CONNECTICUT SITING COUNCIL

May 26, 2016

RE: **PETITION NO. 1221** - Windham Solar LLC petition for a declaratory ruling that no Certificate of Environmental Compatibility and Public Need is required for the proposed construction, maintenance and operation of two 1.0 Megawatt and one 1.5 Megawatt Solar Photovoltaic Electric Generating facilities located at 91 Plainfield Pike Road, Plainfield, Connecticut.

Petition No. 1221
Interrogatories
Set Two
May 26, 2016

Vernal Pool Drawing Map Sample from Docket No. 455

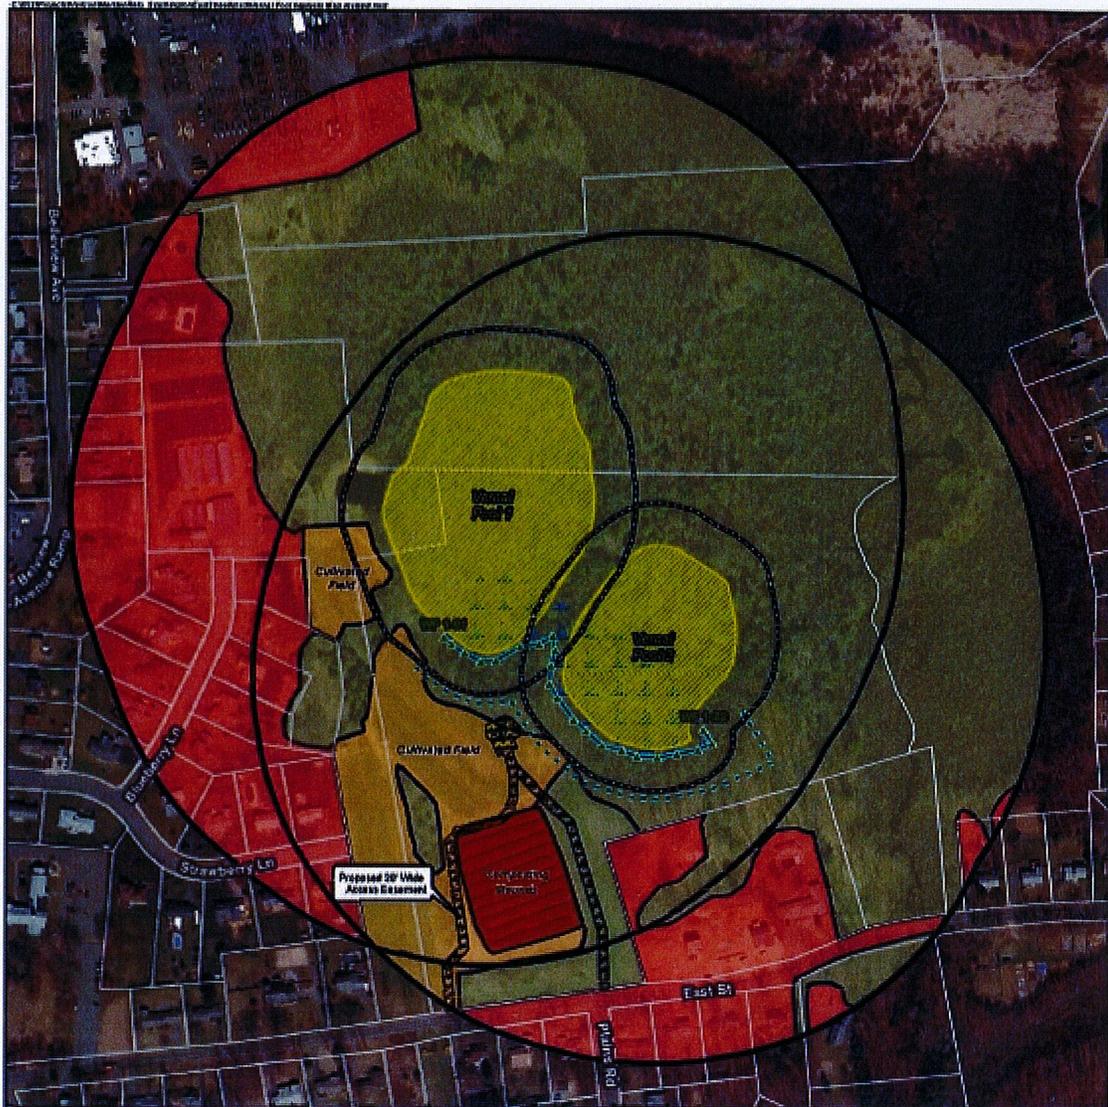
43. If WS secured access to the North Project, provide a wetland report for the north property if wetlands exist on that site. Include a Klemens and Calhoun 2002 Vernal Pool analysis if vernal pools exist. Provide a diagram to scale with the vernal pool analysis showing the shape and locations of the vernal pools on the subject property and the property to the north for the North Project (if applicable) and include the 100-foot vernal pool envelopes (VPE) and the 100-foot to 750-foot critical terrestrial habitat (CTH) along with the proposed project. Compare the existing percent development areas of the VPEs and CTHs to the post-construction percent development areas of the VPEs and CTHs. Attached please find the Docket No. 455 sample diagram.
